Atari Technical Bulletin
Number: TT30-0004
Date: March 27, 1992
Page 1 of 3

Product(s) Affected: TT030
Model: All
Type of ATB: As Needed
ECO #: 1434

To correct boot up problems on C301763-001 REV D FAB boards after ATB TT30-0002 or ECO 1425 was applied.

Figure 1

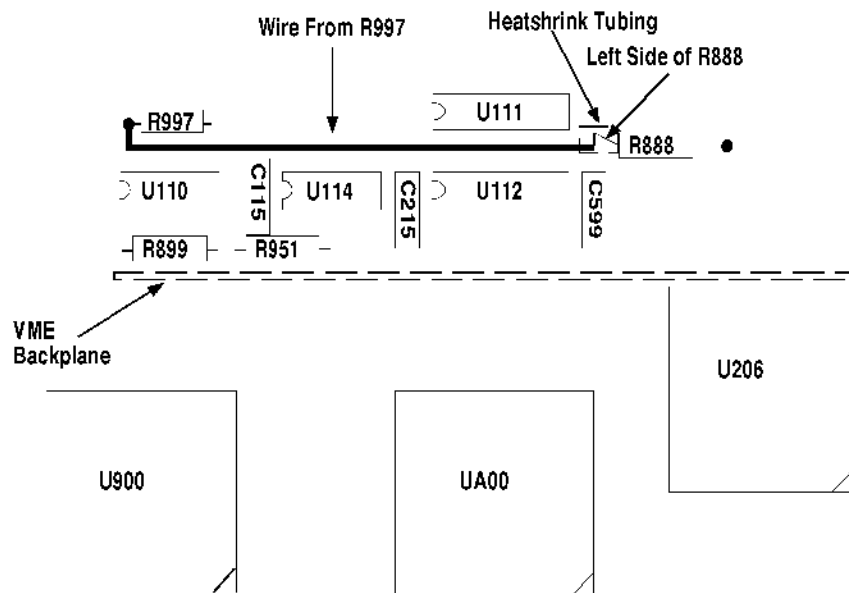
3. If ECO 1425 or ATB TT30-0002 is not installed, skip to step 4. If the first oscillator modification is installed, ECO 1425 or ATB TT30-0002, remove the wire from the left side of R888 and R997. See Figure 1.
4. Lift pins 3 and 17 of U210 so the pins are clear of the pads on the main PCB. See Figure 2.
5. Connect a wire from the right side of R997 to U210 pin 17. See Figure 2.
6. Connect a wire from U210 pin 3 to the left side of R888. See Figure 2.
7. Insulate the connection at R888 with Heatshrink Tubing to guard against any possible shorts. See Figure 2.
8. Re-assemble the unit.
